January 6, 2000
1940-99-20662

Subject: Oyster Creek Nuclear Generating Station
Facility License No. DPR-16
Docket No. 50-219
Response to Request for Additional Information re:
Proposed License Amendment for Spent Fuel Pool Expansion

Enclosure 1

Attachment 1.5

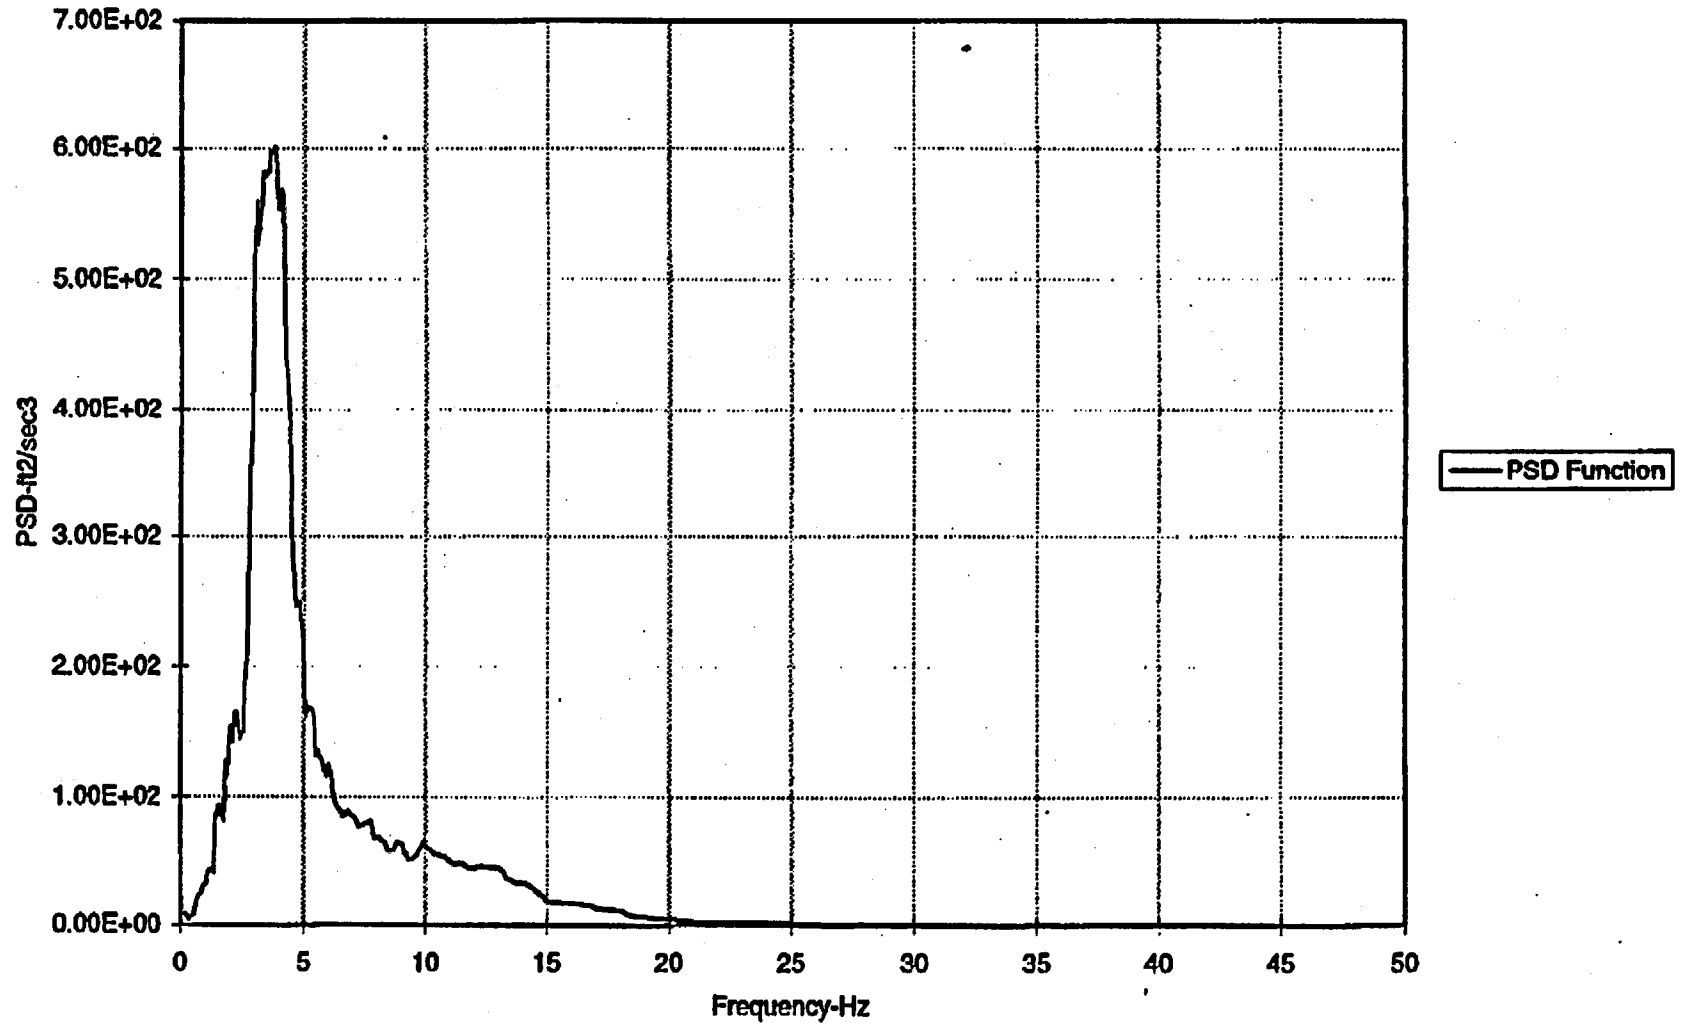
- (c) Provide the physical dimensions of the racks, and the gaps between the racks and the gaps between the racks and the spent fuel pool (SFP) walls.
- (d) Demonstrate that the artificial seismic ground motion time histories used in the analyses satisfy the power spectral density (PSD) requirement of SRP 3.7.1.

The SSE time histories for use in the DYNARACK analyses were also developed by EQE. Attachment 1.4 presents Section 7.0 and Figures 7-1 through 7-6 from the EQE calculation which demonstrate that the time histories derived contain the correct energy distribution with respect to frequency. The OBE time histories, which were generated by Holtec International, also meet the PSD requirements of SRP 3.7.1. Attachment 1.5 contains figures, which provide a comparison of the PSD curves associated with the generated time histories and the PSD curves associated with the design basis response spectra. These figures clearly show that the generated PSD curves envelop the target curves over the entire frequency range.

The "raw" and smooth power spectral density functions are shown in Figures 7-1 to 7-6. There, it is shown that the generated horizontal time histories have the energy concentrated in the 3 to 4 Hz range and practically no energy after 8 to 10 Hz. The vertical time history has a large amount of energy in the 3 to 4 Hz range but also has energy between 4 and 20 Hz. This is consistent with the target floor response spectra and with the characteristics of the dynamic response of the reactor building.

Isometric View of the Finite Element Mesh

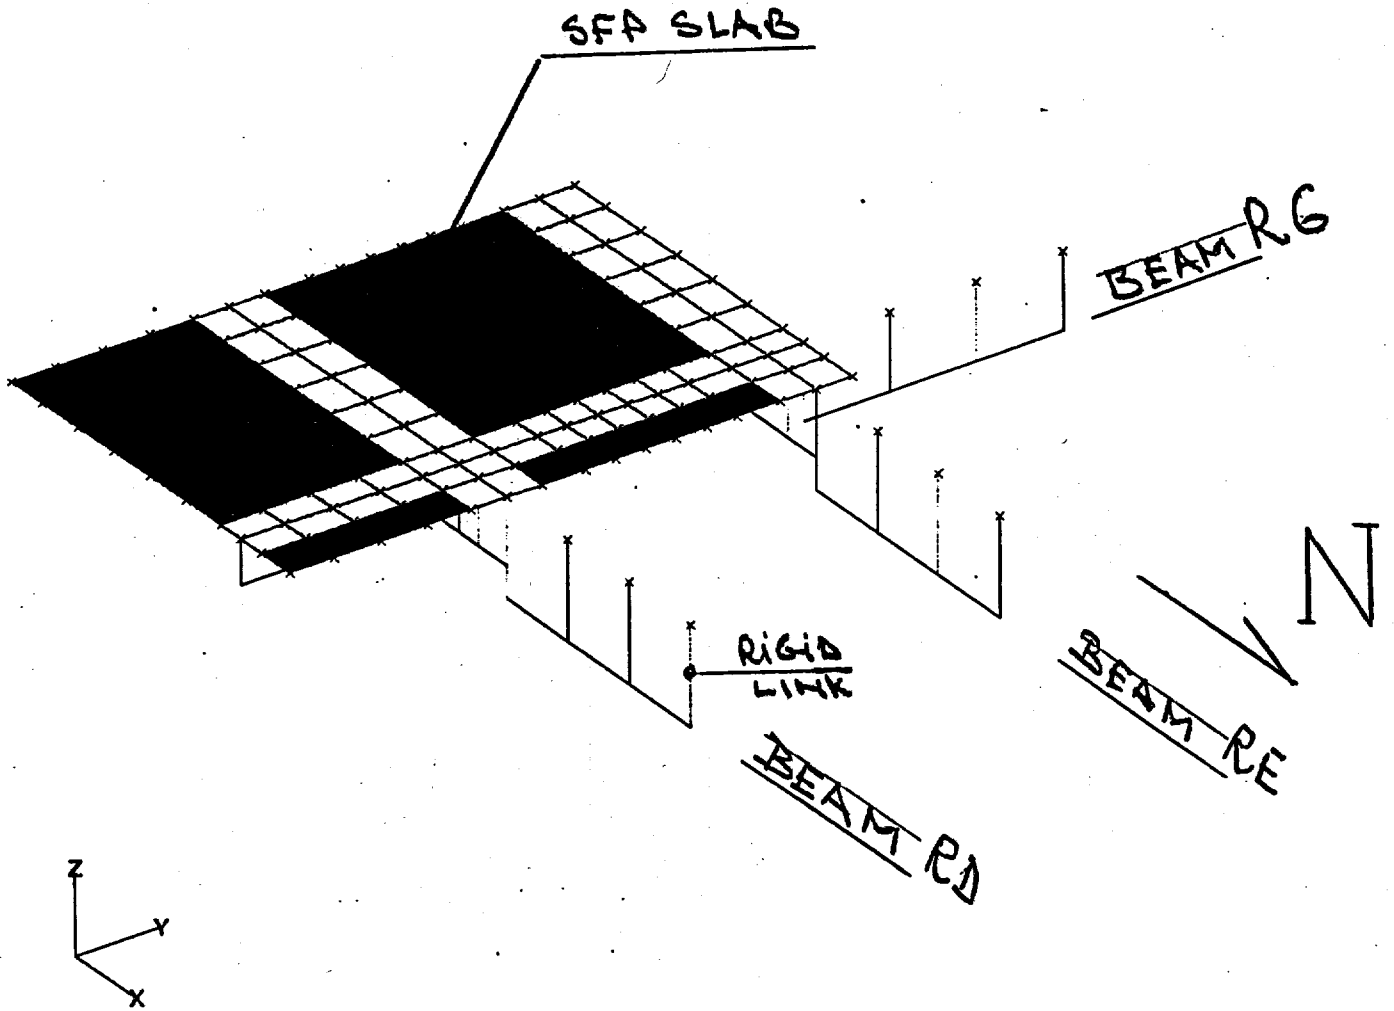
- (a) Provide the physical dimensions of the reinforced concrete slab and walls, liner plate and the details of liner anchorage; also provide the material properties used in the analysis.
- (b) Provide the mesh used in the analysis; describe the boundary conditions and indicate them in the mesh.
- (c) Describe the applied loading conditions including magnitudes, and indicate their locations in the mesh.
- (d) Explain how the interface between the liner and concrete slab is modeled, and also, how the liner anchors are modeled; explain how such modeling accurately represents the real structural behavior.
- (e) Provide the calculated governing factors of safety in a tabular form for the axial, shear, bending and combined stress conditions in the spent fuel pool.

The finite element model encompasses the entire area of interest, i.e., the reinforced concrete slab, its three supporting beams, and the SFP walls. Attachment 2.1 provides an isometric view of the mesh. The interaction of the spent fuel pool with the rest of the Reactor Building is simulated by appropriate boundary conditions. Attachment 2.2 indicates the type and locations of the boundary conditions.

[†] Attachment 2.1 shows the locations of the structural elements.
